RE: **Lot 10 Block 2 Volcano Cliffs Unit 22 SAD 228**
6327 Camino Alto Rd. NW
Grading and Drainage Plan
Engineers Stamp Date 5/12/2020 (D10D003C10)

Based upon the information provided in your submittal received 6/17/2020, this plan is approved for Grading Permit.

SUBMITTED FOR:		SHEET TITLE:		PROJECT NAME:		VOLCANO CLIFFS 6327 CAMINO ALTO RD NW PULTE ID 5							
GRADING PERMIT		GRADING AND DRAINAGE PLAN											
SHEET NUMBER:		1 OF 1

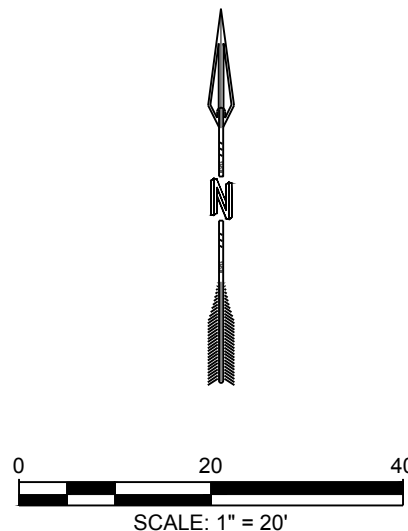
Prior to Building permit approval a Pad Certification will be required, provided by the Engineer or a registered Land Surveyor.

Reiterate to the Owner/Contractor that a separate permit for a garden/retaining wall must be obtained with the approved G&D plan and Pad Certification. **Also, if a swimming pool is to be placed the grading and drainage plan will change and will need to be resubmitted.**

Prior to Certificate of Occupancy release, Engineer Certification per the DPM checklist will be required.
